**COMMITTEE OF THE WHOLE JUNE 16, 2003**

**BLOCK 11 BLOCK PLAN  
NINE-TEN WEST LIMITED ET AL  
BLOCK FILE: BL.11.2001**

<h1>ATTACHMENT '1'</h1> <h2>BLOCK PLAN</h2>		FILE #:	REPORT #:	CITY OF VAUGHAN PLANNING DEPARTMENT	APPLICANT: NINE-TEN WEST LIMITED, ET. AL	DATE:	06/12/2003
		BL.11.2001	LOCATION: LOTS 16 TO 20, CONCESSION 2			SCALE:	NOT TO SCALE

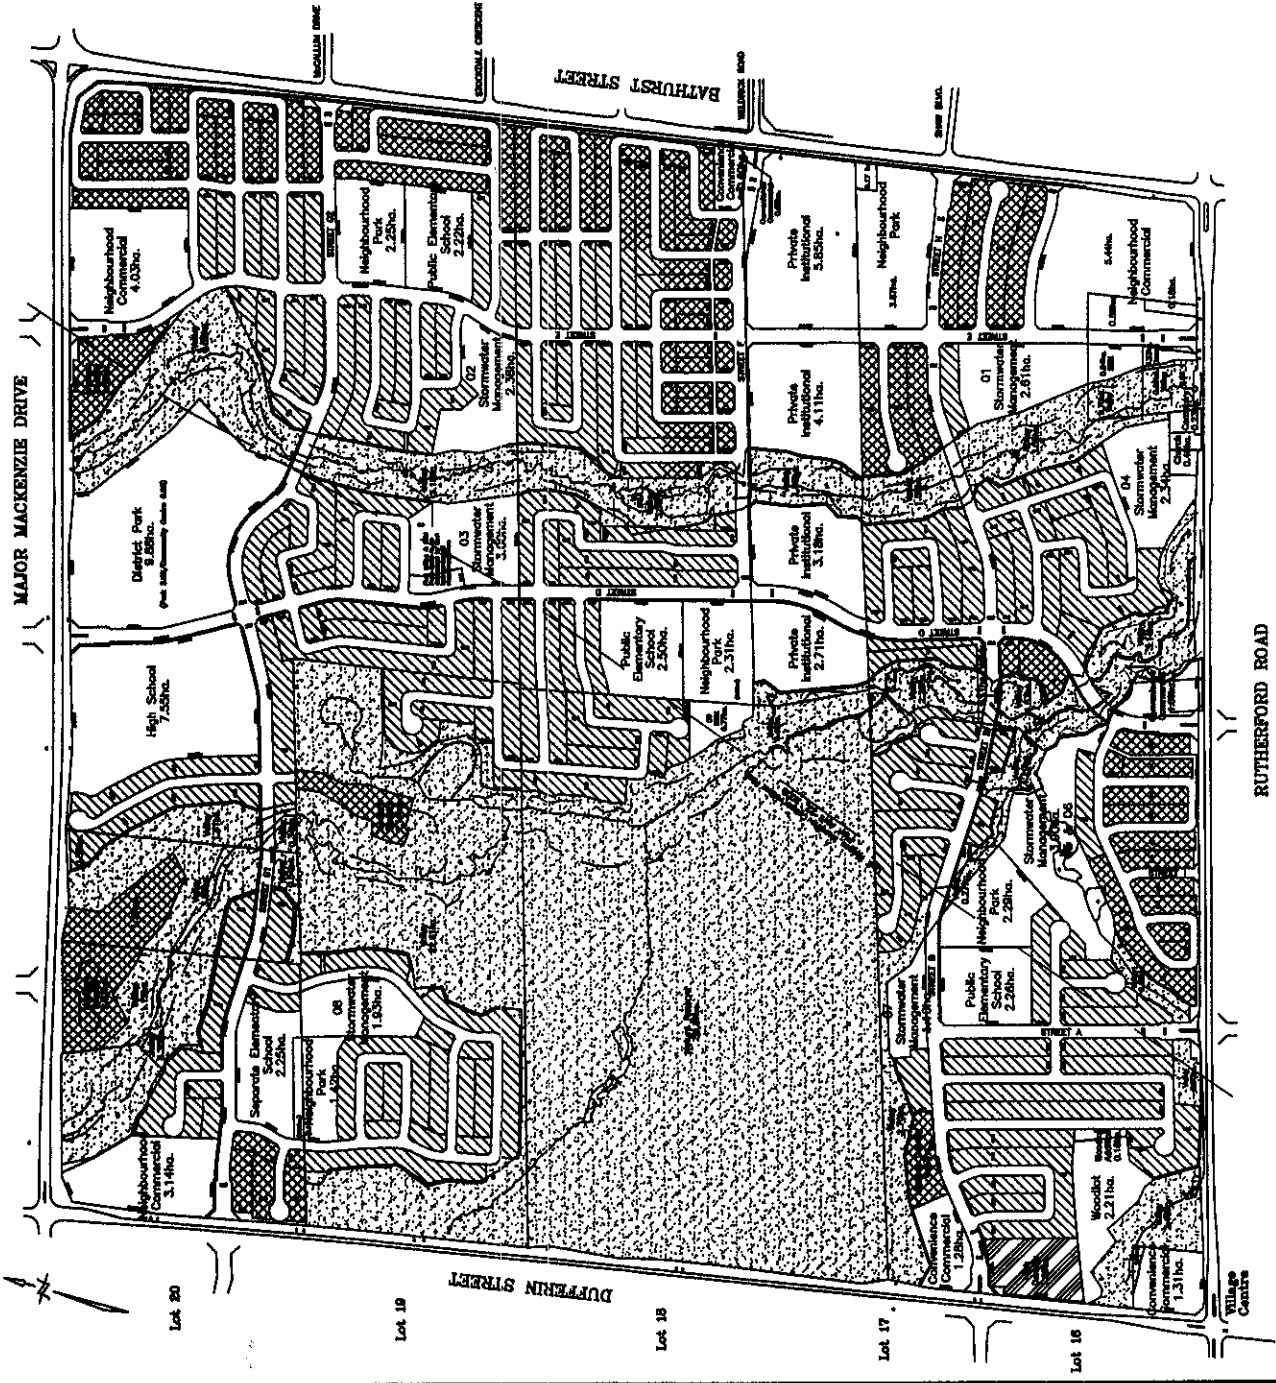
7. The March 24, 2003 Block Plan provided as Document 22 identifies the Regional flood line encroaching on future private lands in the area north and east of Street F and Street D respectively. Re-lotting is required in this area.”

Further, Document 28 identifies four proposed cul-de-sacs within the Block with more than 40 units fronting each cul-de-sac (up to 62 units). Generally the City does not allow more than 40 units on a cul-de-sac due to water supply and access issues. Modifications to the Block plan or re-lotting should be considered to reduce the number of units on the proposed cul-de-sacs.” Therefore, this condition is **partially satisfied**.

Staff comment: The conditional approval of Block 11 on November 25, 2002, included the crescent as described above. The latest version of the block plan dated 3 June 2003 has been changed to show a cul-de-sac with lots flanking along the east property limits of the Neighbourhood Commercial site. This type of lotting fabric creates an inappropriate interface between the residential lots and the commercial use. Planning and urban design staff note the need to show the crescent as approved by Council on Nov. 25, 2002. Therefore, this additional condition has been added.

- h) That the block plan be revised to include a crescent north of Street G1, abutting the Neighbourhood Commercial site at the corner of Dufferin Street and Major Mackenzie Drive.

**ATTACHMENT '2'  
BLOCK PLAN**

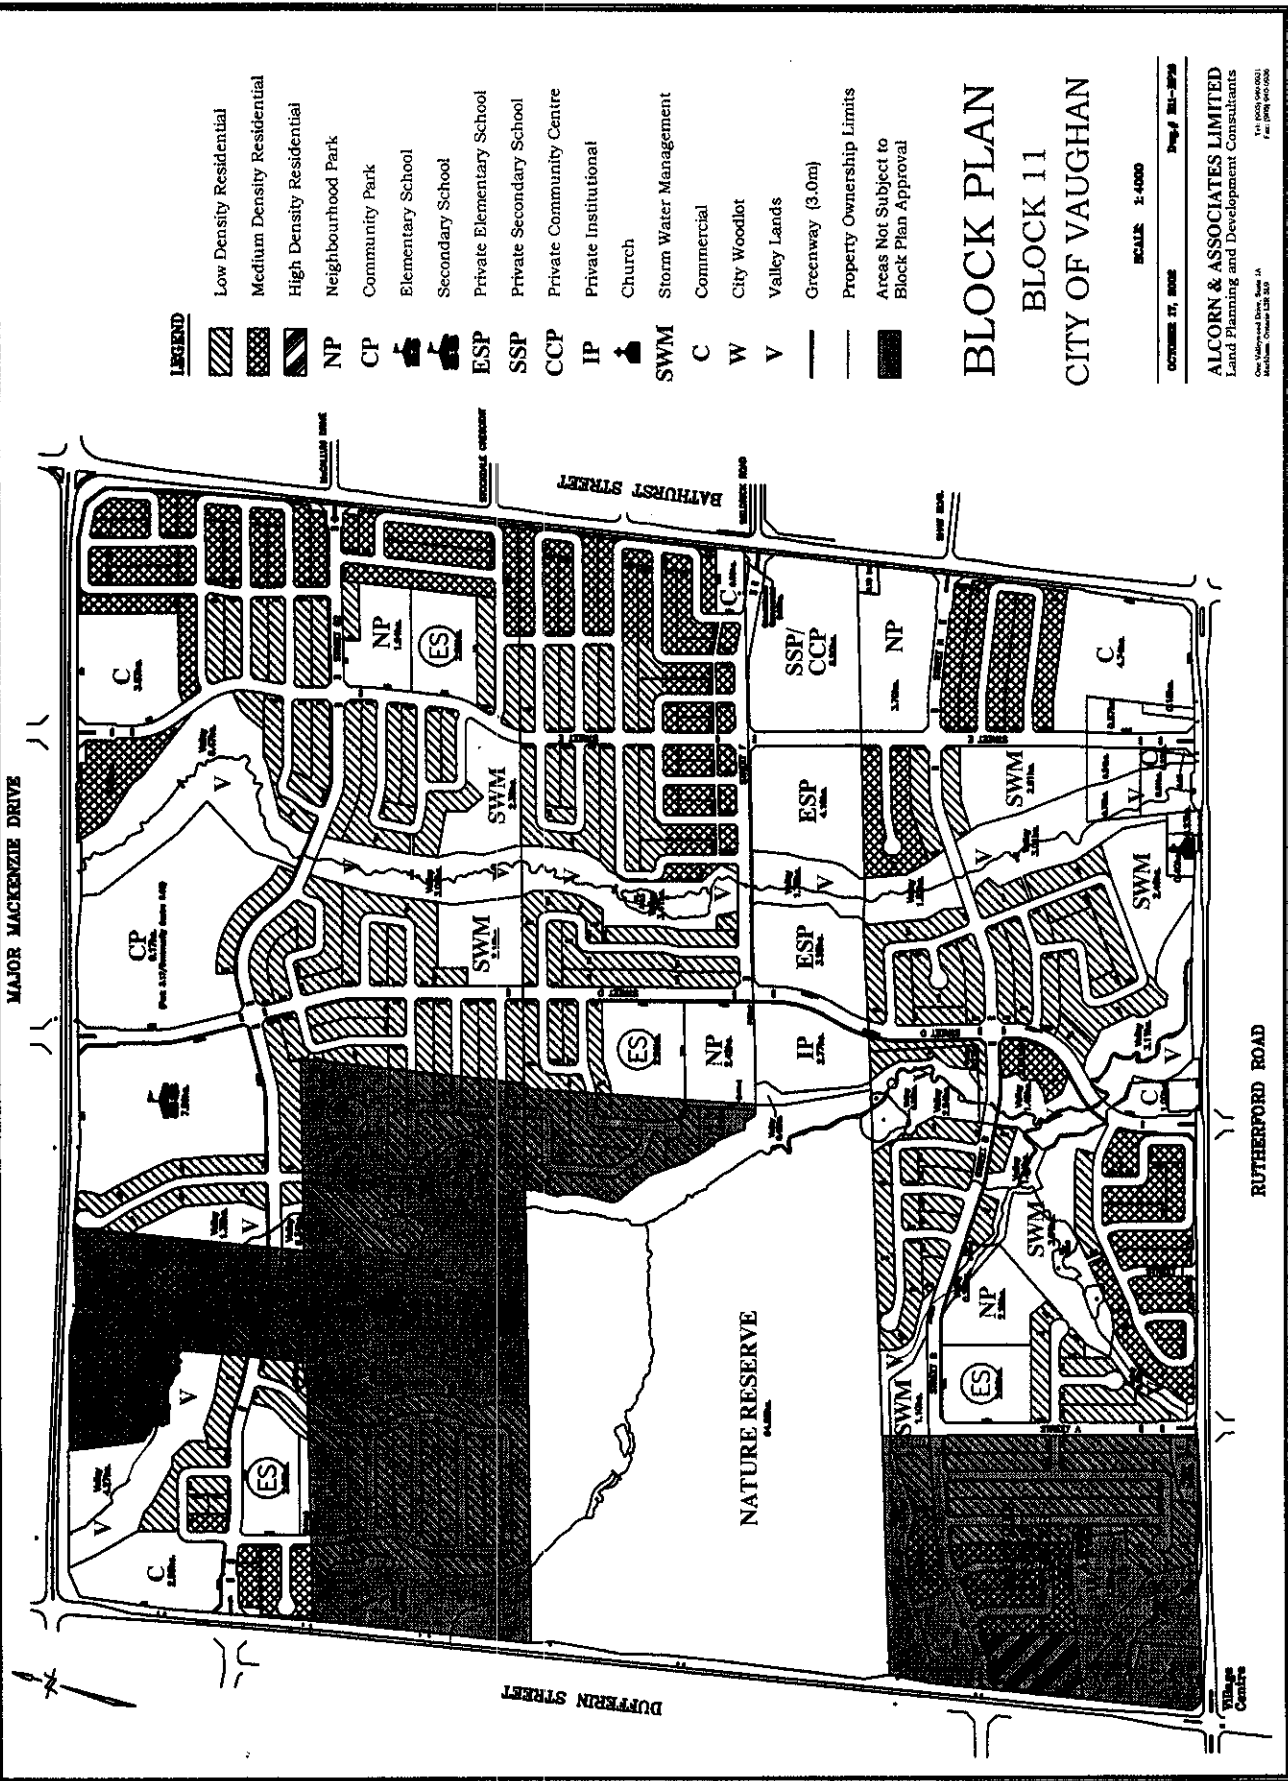
Response: As noted on **Schedule XX**, the conditions discussed in this report do not pertain to those properties which were not part of the conditional Block 11 Plan approval. Staff are working with the affected landowners to resolve their issues, with the objective of including these lands, if possible, in a final approval of Block 11. The condition remains **outstanding**.
